CHART STANDARDIZATION & PAPER CHART WORKING GROUP (CSPCWG)

CSPCWG Letter: 13/2012

Subject: Actions arising from 8th CSPCWG meeting – Group 2; follow-up to Letter 08/12

Annex A Consolidated responses to WG Letter 08/2012 and outstanding issues
Annex B Consolidated comments on WG Letter 08/2012 and Chairman's responses

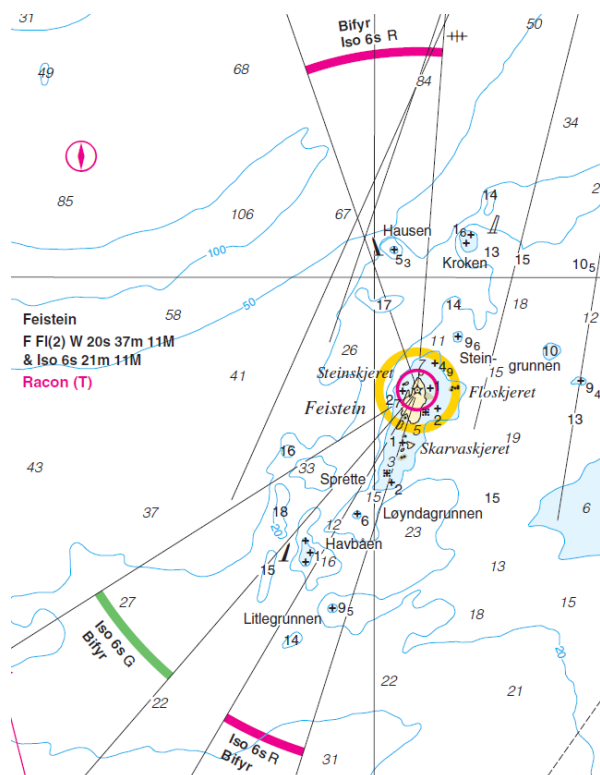
Action 12: iii. Sector limits should be **shown as fine continuous lines, but may be fine dashed lines.**

Emphasis may be provided by 1mm wide colour bands where marking the sides of a fairway (see B-475.1, B-475.5 and INT1 P41.2).

iv. Sector arcs should **be shown solely by coloured arcs, but may be fine dashed lines.**

Chairman: See response to GR.

Chairman: See response to GR.
